PRELIMINARY FINAL PROOF SURVEY UNDER

TRANSFER NO. 3095
Application No. 52198 Permit No. 39303
IN NAME OF
WILD RIVER ORCHARDS, INC.
Surveyed JAN. 18, 1984, by B. S. JAMES

T. 36 S., R. 6 W., W.M.

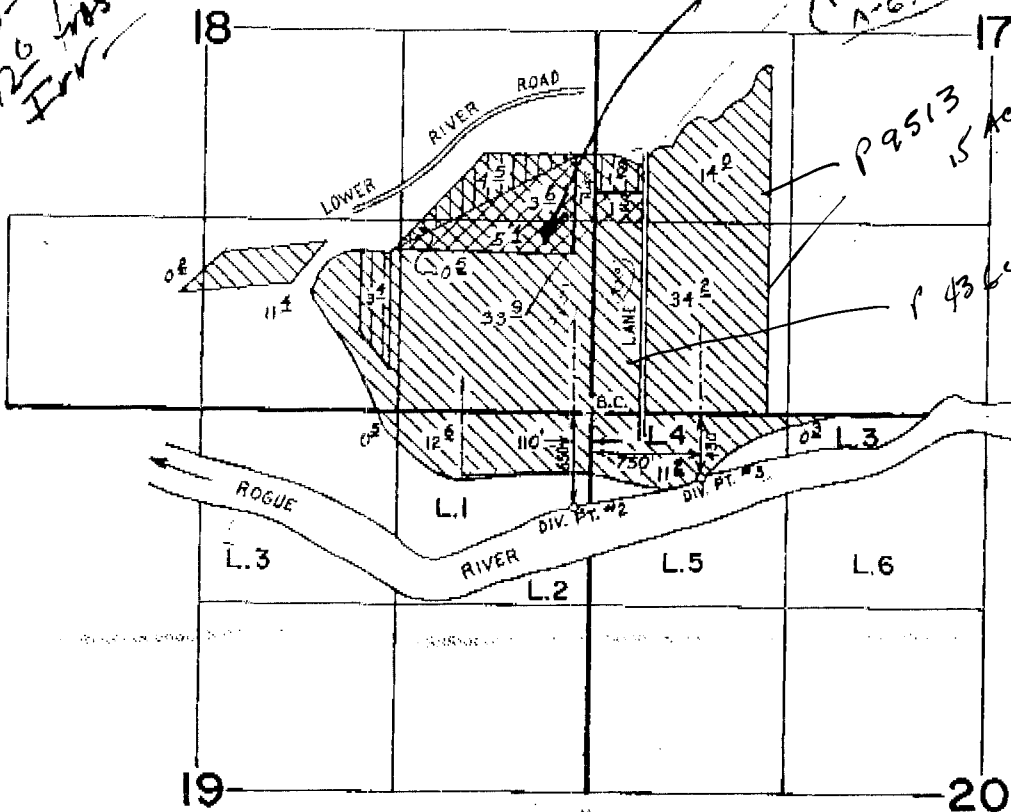
*why doesn't
all land have an
irrigation watermark?
18 SWSE 158 foot but only
19 NENE 120 foot but no
Irr.?*

*allow 13 here
ACCORDY 38'
UNDER RR
(P-4364
A-6969)*
